DYER WHARF I-195 DESIGN PRESENTATION

2.2.2026

CV Properties LLC
DEVELOPMENT + INVESTMENT + MANAGEMENT

WAIVER 1 LONG-TERM BICYCLE PARKING

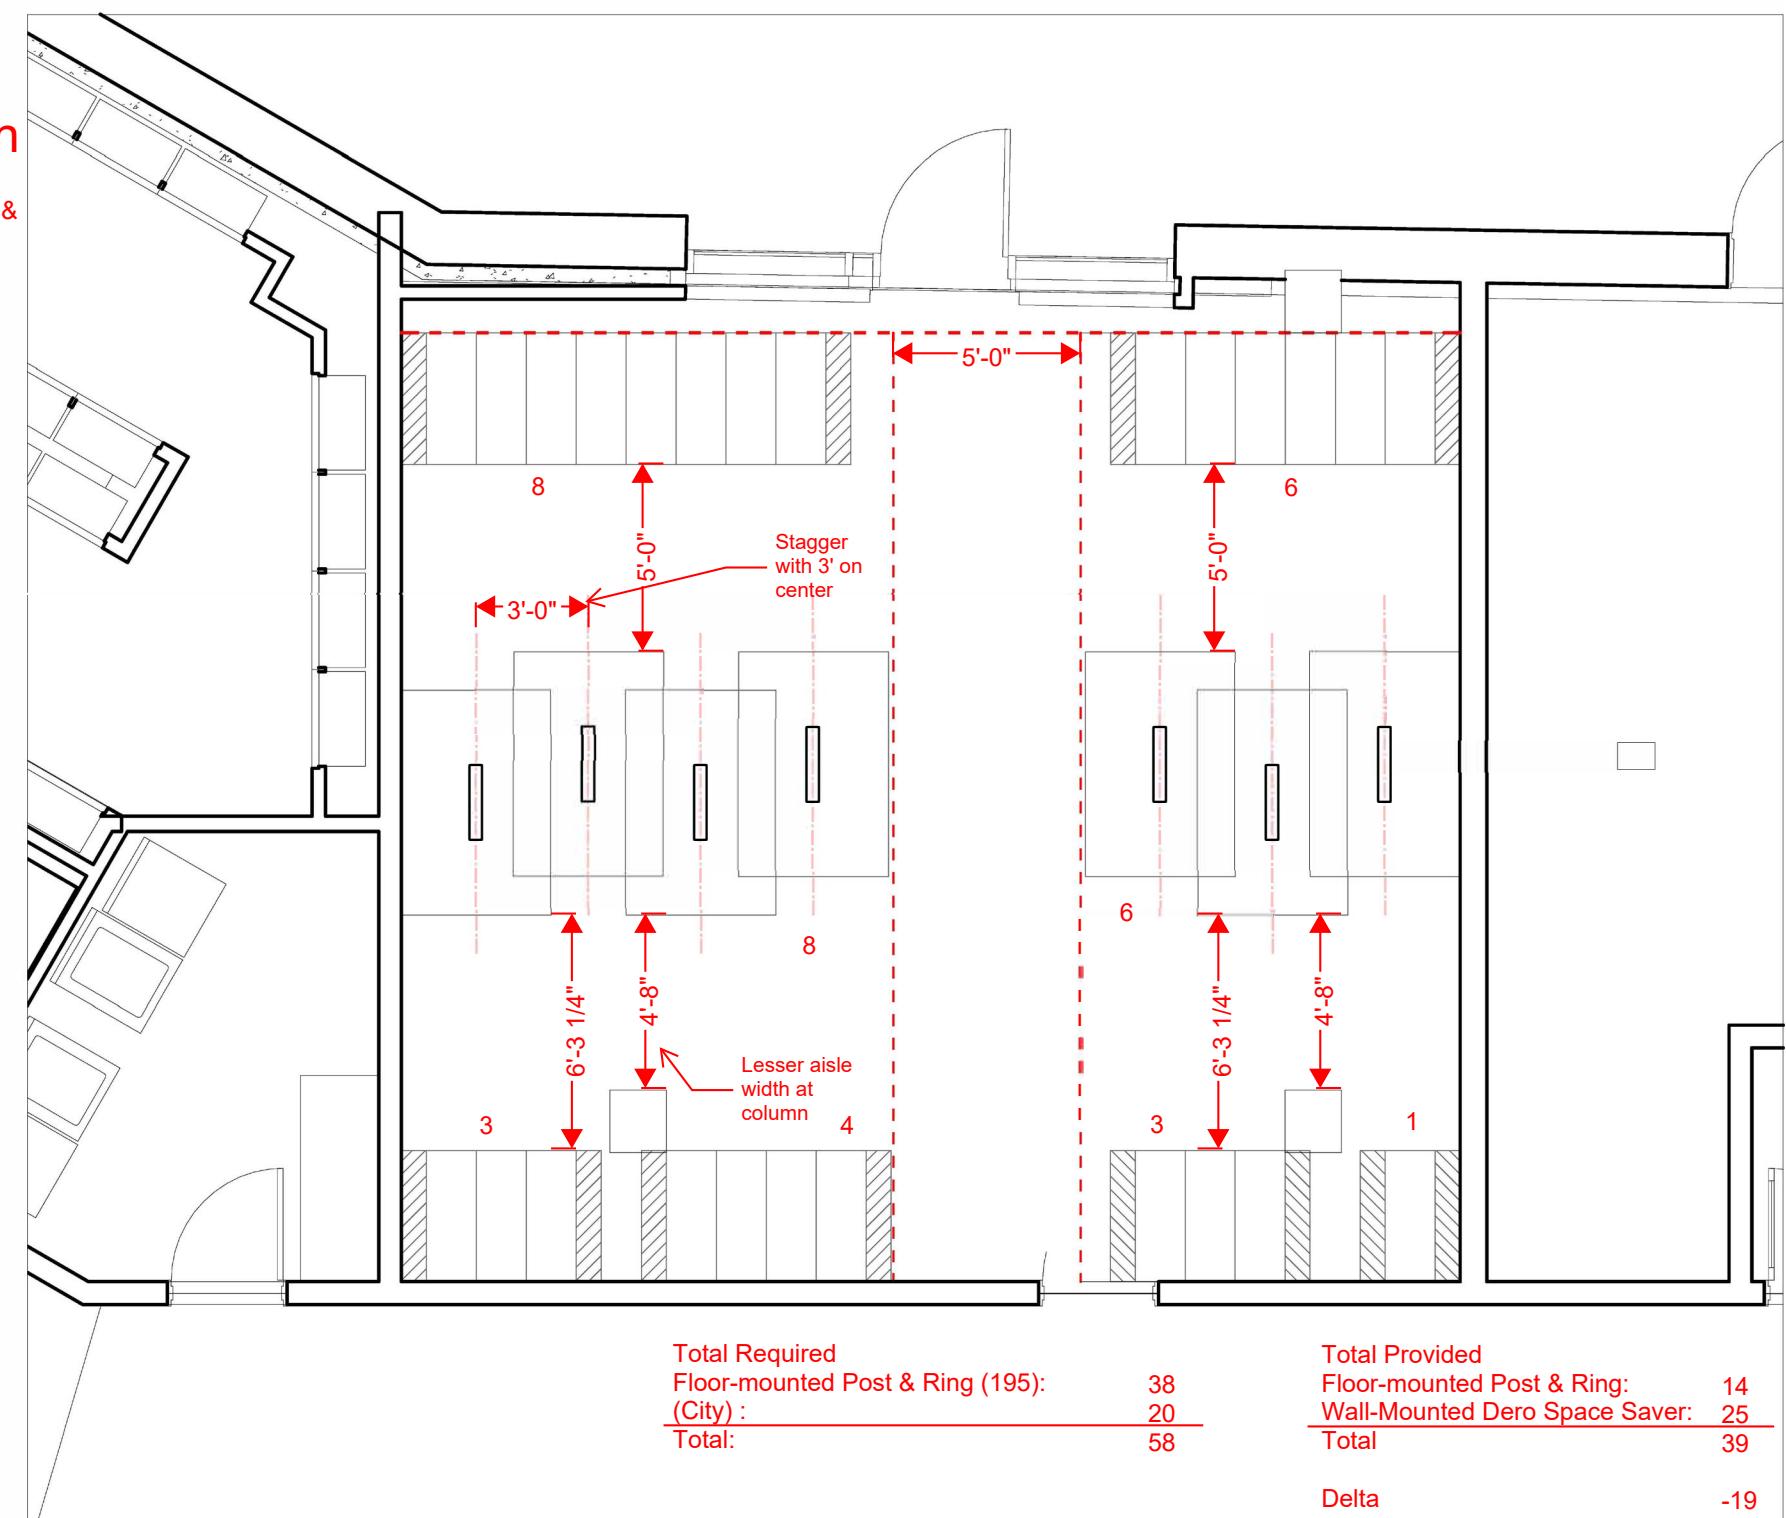
2.4 PARKING & LOADING, SECTION 2.4.D
BICYCLE PARKING DESIGN STANDARDS,
TABLE 2.4-1 MINIMUM BICYCLE PARKING
REQUIREMENTS & DIMENSIONAL STANDARDS
2.4.D.1.A AND 2.4.D.2.C.

A REDUCTION IN THE MINIMUM NUMBER
AND AN ALLOWANCE FOR ALTERED DESIGN
FOR A LIMITED NUMBER OF THE REQUIRED
LONG-TERM BICYCLE PARKING SPACES.
SPECIFICALLY, ALLOWING THE DESIGN OF
THE BIKE ROOM ATTACHED TO THIS MEMO
AS EXHIBIT 1, WHICH USES A MIX OF FLOOR-
MOUNTED POST AND RING RACKS AND
WALL-MOUNTED RACKS, FOR A TOTAL OF
39 SPACES. BECAUSE THIS IS THE FIRST
AND MOST DIMENSIONALLY CONSTRAINED
PHASE OF A MULTI-PHASE DEVELOPMENT,
WE RECOMMEND THAT THE DEFICIT OF
19 LONG-TERM BICYCLE PARKING SPACES
ASSOCIATED WITH THIS DEVELOPMENT BE
PROVIDED AS PART OF THE LATER PHASES OF
THE DEVELOPMENT AND MADE AVAILABLE TO
RESIDENTS OF THIS BUILDING.

WAIVER 2 SHORT-TERM BICYCLE PARKING

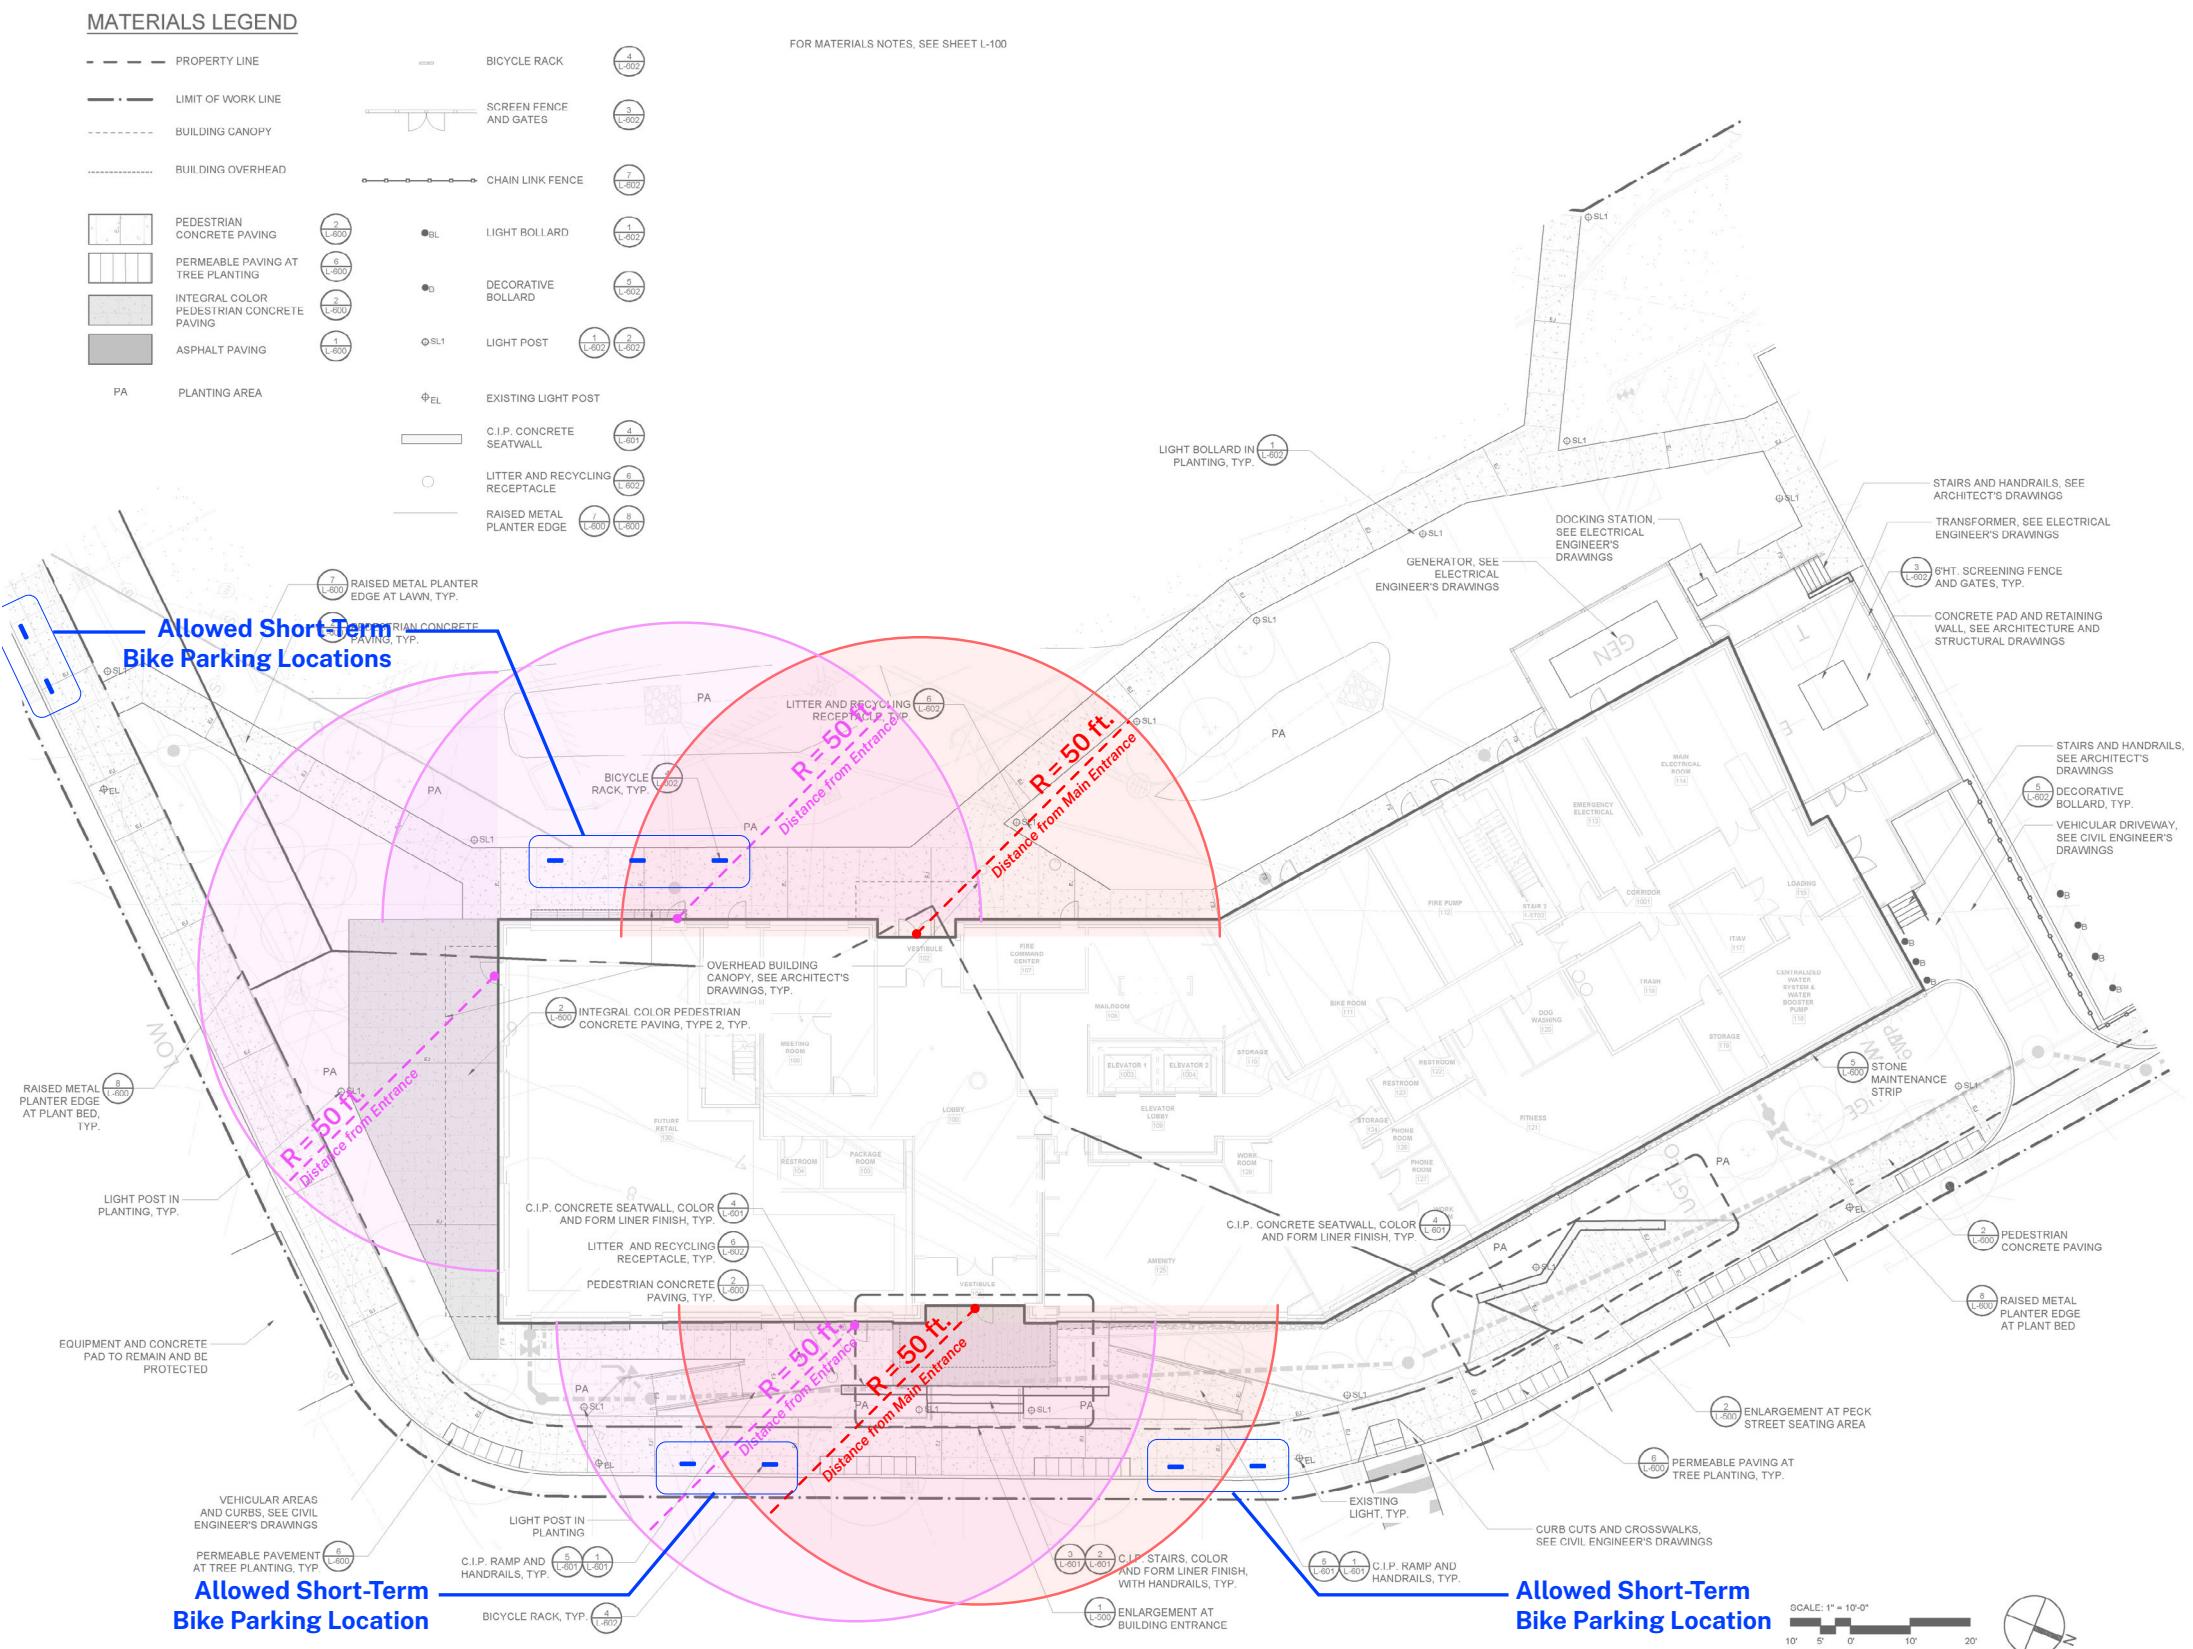
2.4 PARKING & LOADING, SECTION 2.4.D.1.B BICYCLE PARKING DESIGN STANDARDS

AN ALLOWANCE FOR THE REQUIRED SHORT-TERM BICYCLE PARKING SPACES TO BE LOCATED MORE THAN 50FT FROM THE PRIMARY ENTRYWAYS TO THE RESIDENTIAL UNITS AND GROUND FLOOR RETAIL SPACE, PROVIDED THE SPACES ARE LOCATED ON THE CLOSEST AVAILABLE LEVEL SIDEWALK OR PLAZA SPACE THAT AVOIDS CONFLICTS WITH CROSSWALKS AND ACCESSIBILITY FEATURES, STREET TREES, ABOVE-GROUND UTILITY FEATURES, AND WALKWAYS FORM SIDEWALK GRADE TO DFE-1. SPECIFICALLY, ALLOWING SHORT-TERM BIKE PARKING SPACES TO BE LOCATED IN THE PLACES INDICATED BY THE DIAGRAM ATTACHED TO THIS MEMO AS EXHIBIT 2.

WAIVER 3 EXTERIOR LOADING DOCKS

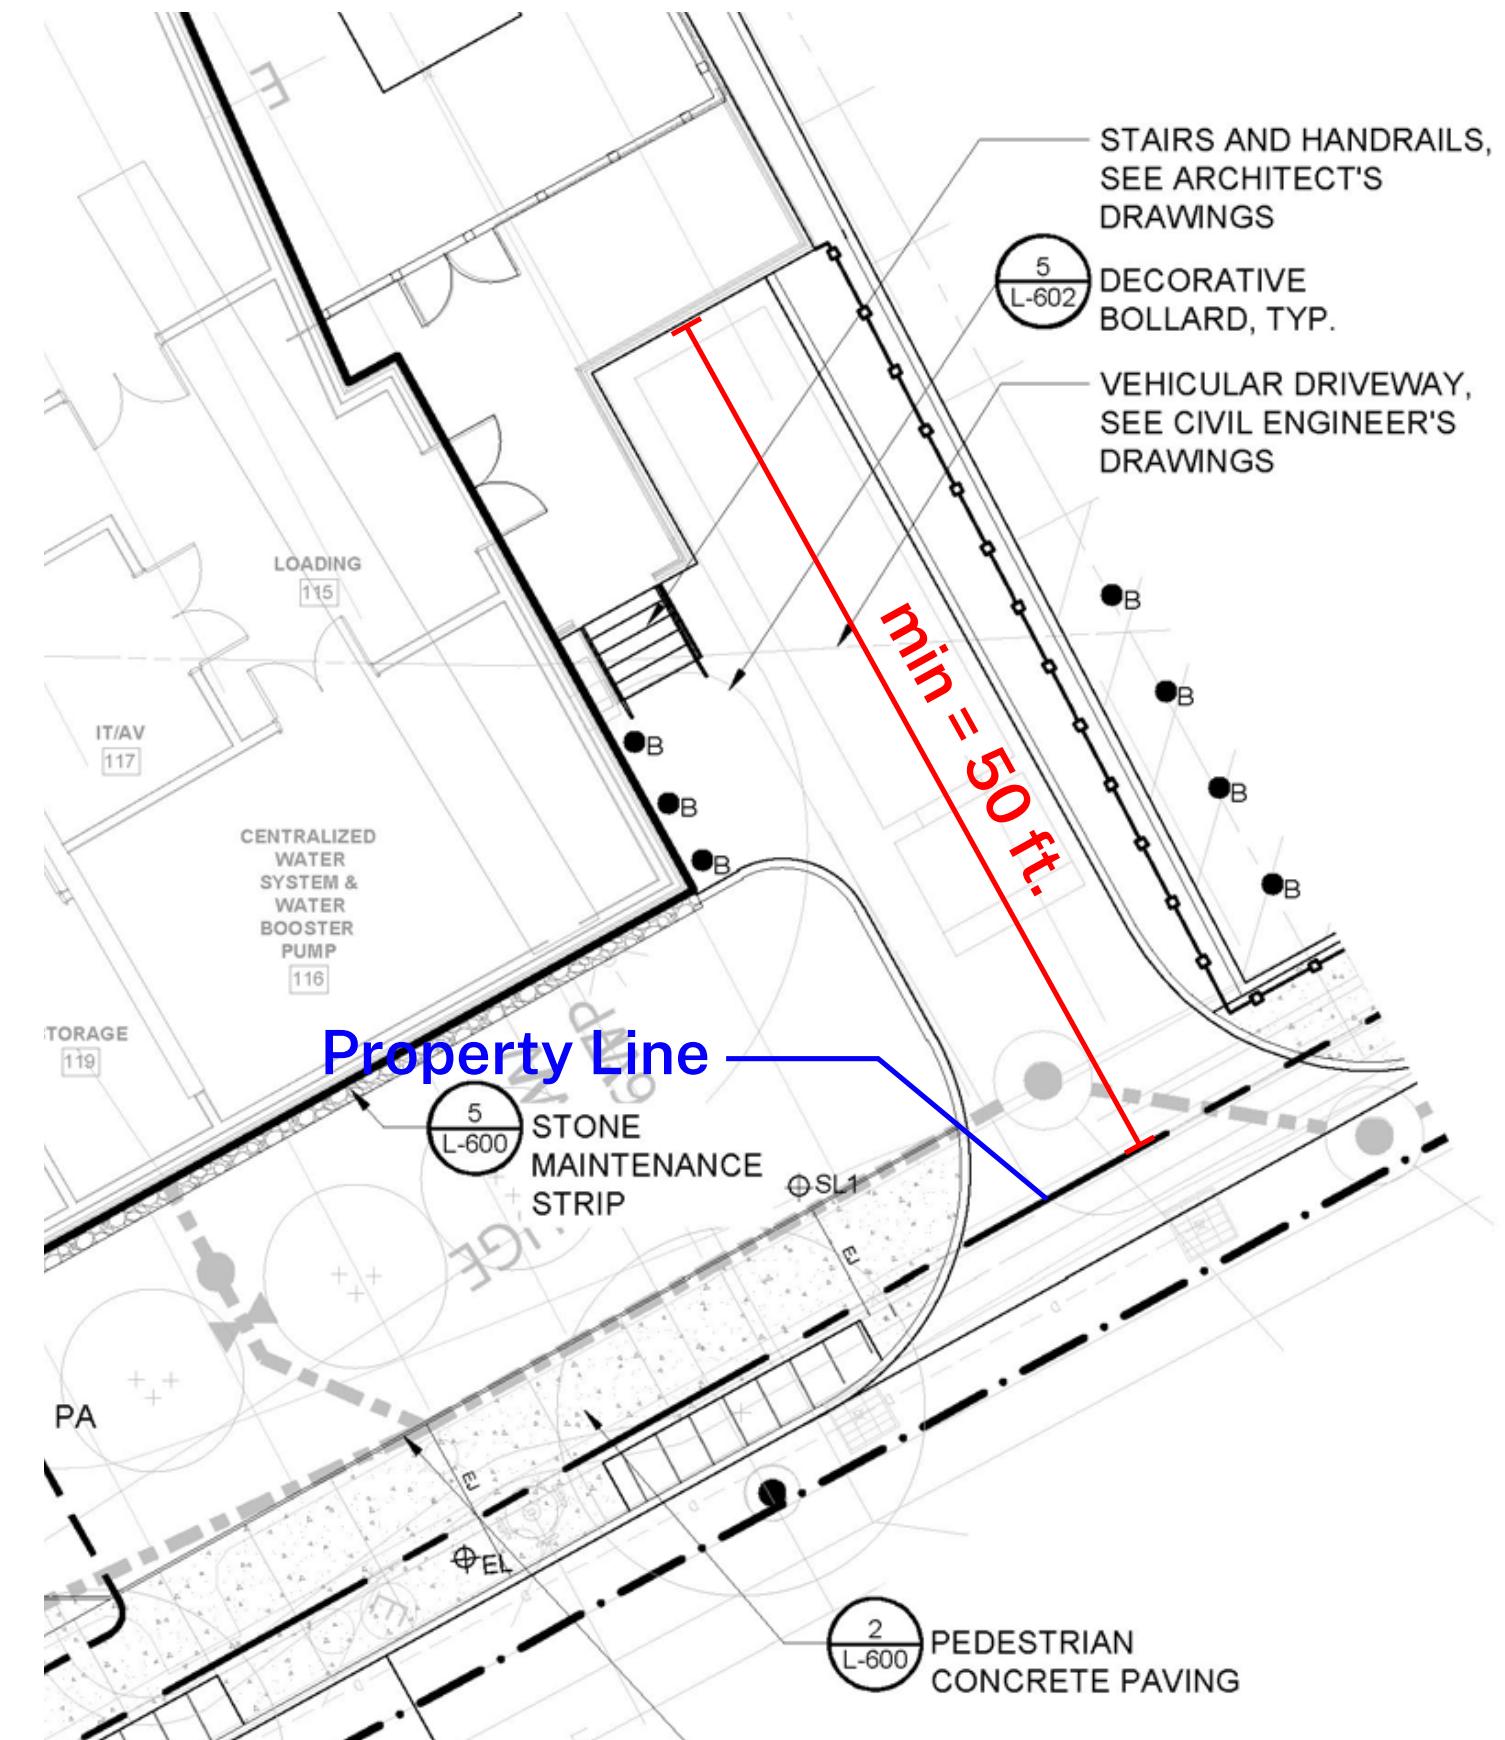
2.4 PARKING & LOADING, SECTION 2.4.E.3

ALLOW AN EXTERIOR LOADING DOCK ALONG PECK ST WHERE THERE WILL BE THE LEAST IMPACT ON PUBLIC REALM EXPERIENCE, PROVIDED THEY ARE SET BACK FROM THE PROPERTY LINE BY AT LEAST 50 FEET AS INDICATED IN THE ATTACHED EXHIBIT 3 AND ALL LOADING SUPPORT SPACES, INCLUDING TRASH, ARE LOCATED ON THE INTERIOR OF THE BUILDING. STAIRWAYS AND PEDESTRIAN ACCESS TO THE LOADING DOCK AND ASSOCIATED INTERIOR SPACES ARE PERMITTED BE CLOSER TO THE PROPERTY LINE.
